## **In response to Göran Ericsson and Stephan Pomp's comments on the 3rd party report,**

*“Comments on the report "Indications of anomalous heat energy production in a reactor device containing hydrogen loaded nickel powder." by G.Levi, E.Foschi, T.Hartman, B.Höistad, R.Pettersson, L.Tegnér, H.Essén.”*

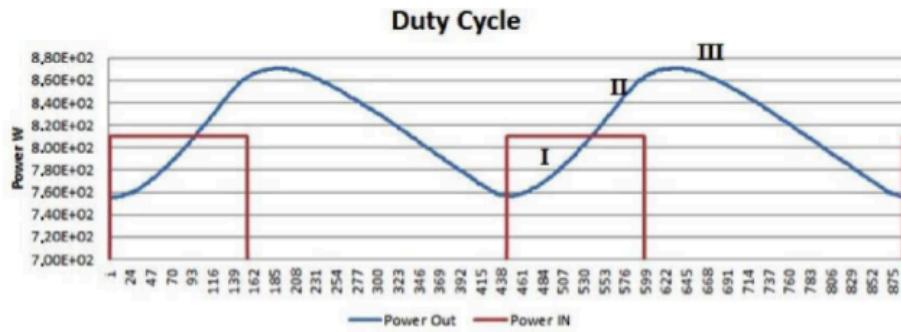
*\* We have performed a thermal analysis using the physics simulation tool “COMSOL” for MatLab, using values for geometry, materials and electrical heating coils extracted from the report (March test, cylindrical part only†). In Fig. 1 we show results from a calculation including resistive heating only (810W for 2min, then 0W for 4 min). The shape of the temperature curve at the surface is quite similar to what is presented in Ref. 1, Plot 3. Since we have not included any anomalous heat source in our model, it seems clear that the observed shape of the temperature at the surface can simply be attributed to heat diffusion from the internal heat source(s) through the steel cylinder to the surface. As a matter of fact,*

*there seems to be no reason whatsoever why the surface temperature curves should look anything like those of a generic resistor (as, e.g., claimed in the caption of Plot 3 on page 25 in Ref. [1]), when this resistor is buried deep within the device.*

*\* Our modeling indicates that the observed time-dependence is perfectly consistent with a situation where the internal heat source is supplied purely by resistive heating. Thus, the argument that the shape of the temperature/power curves is an indication of an anomalous internal heat source is not correct. And even if this has no direct bearing on the existence (or not) of any anomalous heat source within the reactor, the lack of understanding of such a fundamental physical process does not inspire confidence in the presented results.*

*\* From our thermal analysis it is also clear that if any form of pulsed, internal (electrical plus possibly “anomalous”) power is supplied, the temperature (and hence the emitted power) at the surface of the reactor by necessity has to be out of phase with the power contributed by the internal sources. And obviously, the displayed pattern of surface heating and cooling clearly indicates that the internal heat source is not constant. However, the curves presented in [1] (especially Plot 8 on pg 27) show the electrical power and the surface emission power to be in phase. This can have two explanations. The simplest one is that the two curves have been forced “synchronized” for the sake of illustration by the authors. This should then have been clearly pointed out in the report, but, and this is more serious, it would then also constitute a deviation from reporting the actual experimental data as well as withholding important information that could contribute to an understanding of the device and its internal processes. The second possibility could be that the phase and amplitude of the additional anomalous heat source is such as to precisely sync the two curves. We leave it open if such a scenario can even be conceived, but it would of course be a rather remarkable coincidence, and could actually offer an independent possibility to assess some of the properties of the alleged anomalous source. At present we have not had the resources to take our modeling to that level.*

This is seriously only intended to add negative innuendo. The authors of the commentary say though, that this has nothing to do with the claim of excessive heat being generated. Possibly it is so that the self-sustaining mode period is not very long, but it say nothing about if there is a substantial effect while the resistive heating is ongoing. Maybe they should add a component for self sustaining excessive heat, and move the thermal heating into a coil further out, in the model, and try to actually get the temperatures and input energy to match the real experiment.

The authors again indulge in innuendo to paint their negative picture. It could also be so that the curves are in fact so synced because they are, and their model - may be due to its simplicity - has several problems in mimic the real world.

But take plot 8, as they mention in this comment. It is evident that the integrated output is about three times the value of the integrated input (simply integrate the areas under the blue and red curves during one period in your mind and take the difference). This is regardless of any details in the shape of the curves, or the synchronization of ON/OFF state and min/max.
